TIR EXECUTIVE BOARD (TIRExB)
COMMISSION DE CONTROLE TIR (TIRExB)
ИСПОЛНИТЕЛЬНЫЙ СОВЕТ МДП (ИСМДП)

GENERAL
Informal document No. 13 (2007)
2 November 2007

Approval of road vehicles

Approval of vehicles

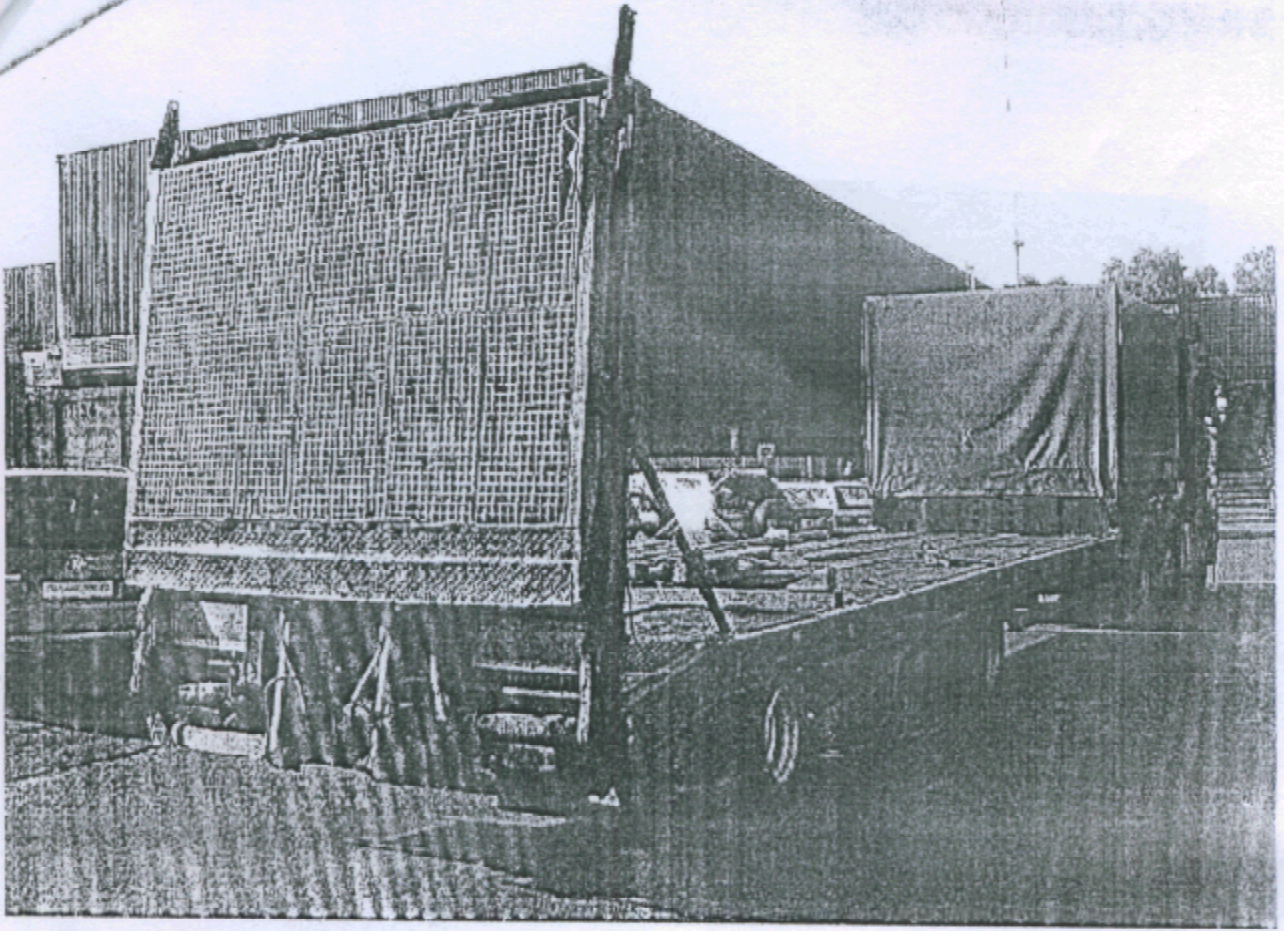
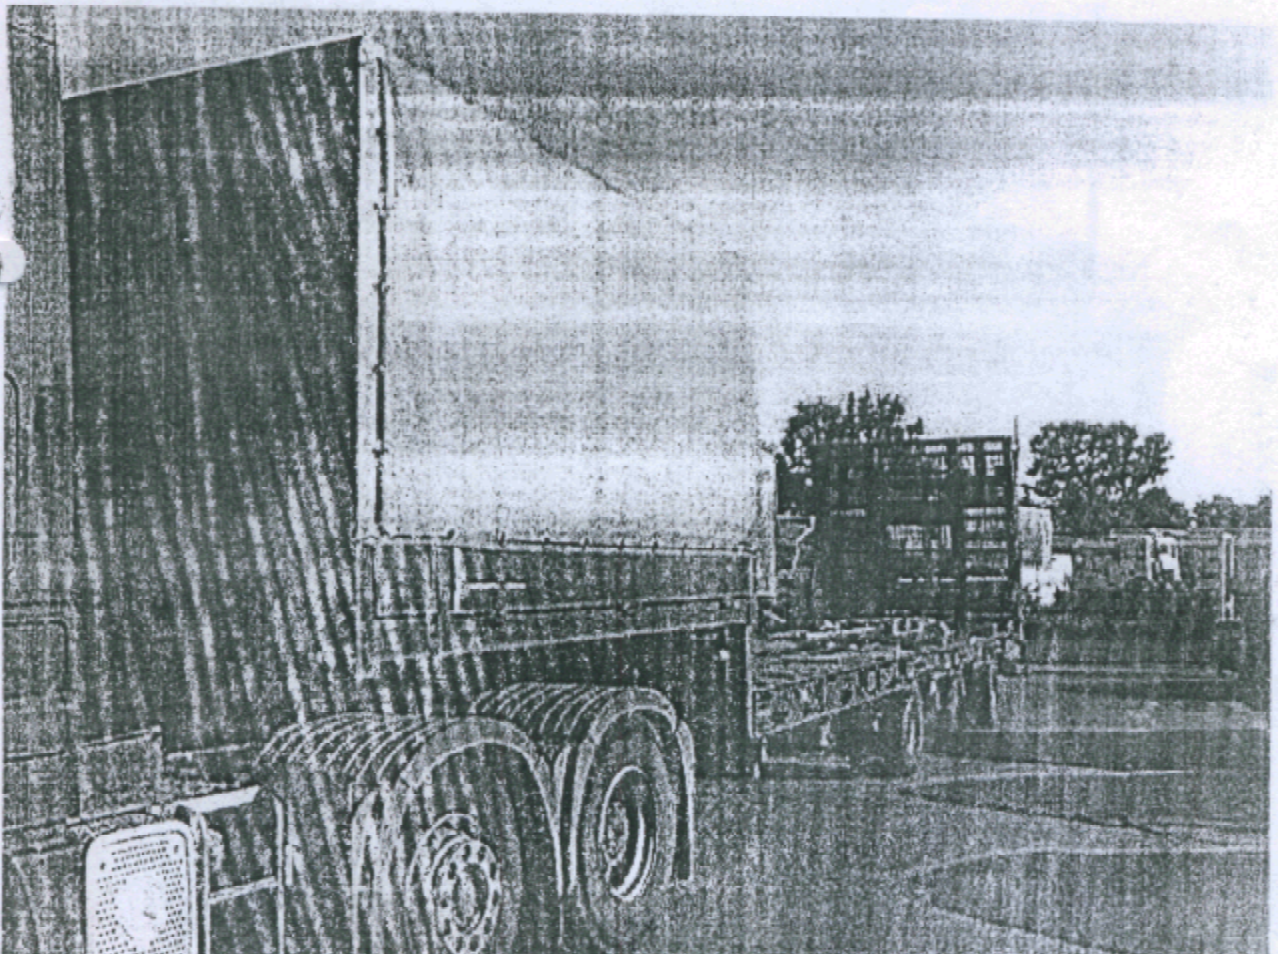
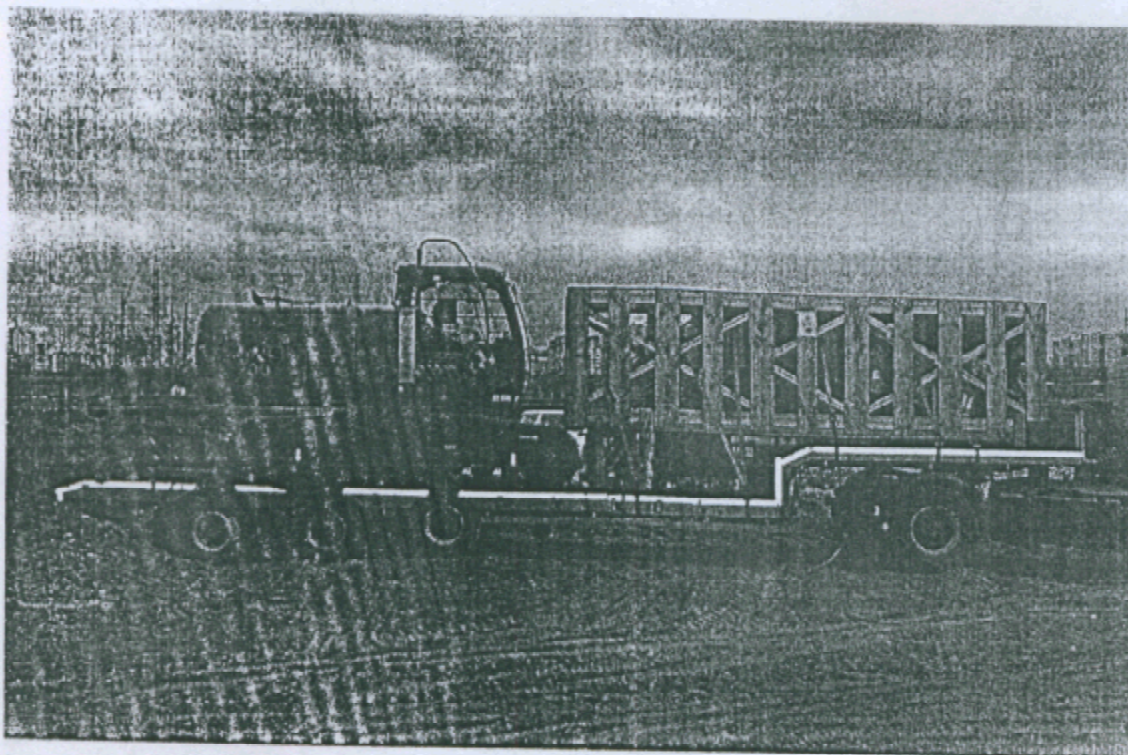
At present time some of them are going to buy special vehicles (annex 1) with the closed customs area at the front side which is in our opinion corresponding to the provisions of the TIR Convention.

- is the admission procedure for the transport of goods under Customs seal possible for this special vehicle?
- is it possible to transport the goods at these type of vehicles with the using of two TIR Carnets (one for the open area and the other one for the closed area)?
